Customer: Cintas

Situation: Auxiliary heater may blow fuse on main dash harness

Corrective Action Summary: Replace heater switch and route new

Range of Units Affected: 2015 Aeromaster on the Ford F59 chassis equipped with auxiliary cab heaters manufactured after January 1, 2016. Contact Utilimaster Warranty Department to verify chassis VIN.

Hole for battery power harness

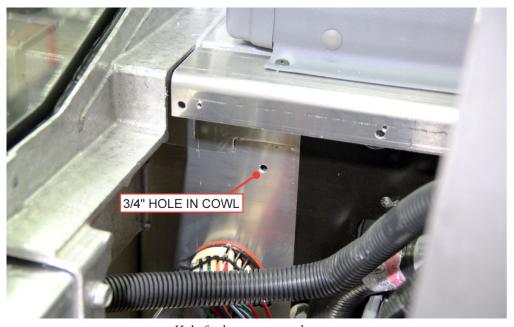
- 1. Disconnect the **Negative (-)** battery cable(s).
- 2. Use an F-bit to drill a pilot hole in the LH cowl.
- 3. Use a 3/4" bit to enlarge hole.

Power harness secured to cowl harness to frame rail

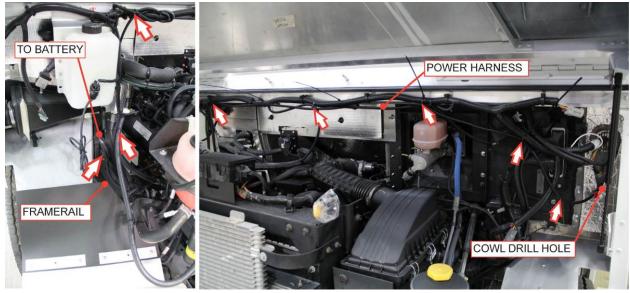
- 4. Feed the heater power supply harness through cowl riser, apply sealant to harness bushing and secure.
- 5. Route power harness along the cowl harness, RH chassis harness and frame rail to the battery box.

Relay Ground wire

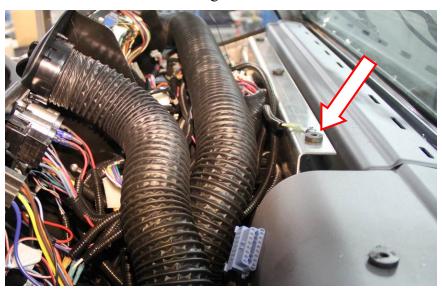
- 8. Drill a 7/32" hole in the dash bracket.
- 9. Cut and strip Ground wire and crimp a ring terminal and terminal connector to each end.
- 10. Secure the WHITE Ground wire ring terminal to the cowl with a 1/4-20 fastener.

Switch wiring

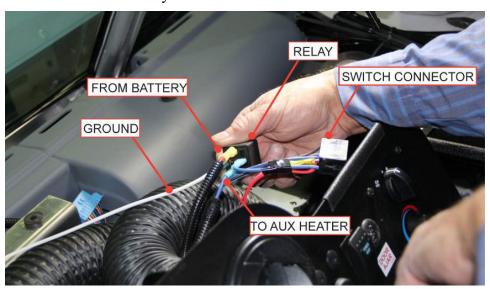
- 11. Cut, strip and crimp a terminal connector to the RED battery harness.
- 12. Cut the DARK BLUE switch wire. Strip wires and crimp terminal connectors to both ends.
- 13. Connect RED Battery harness, both DARK BLUE heater power switch and Ground terminals to relay.
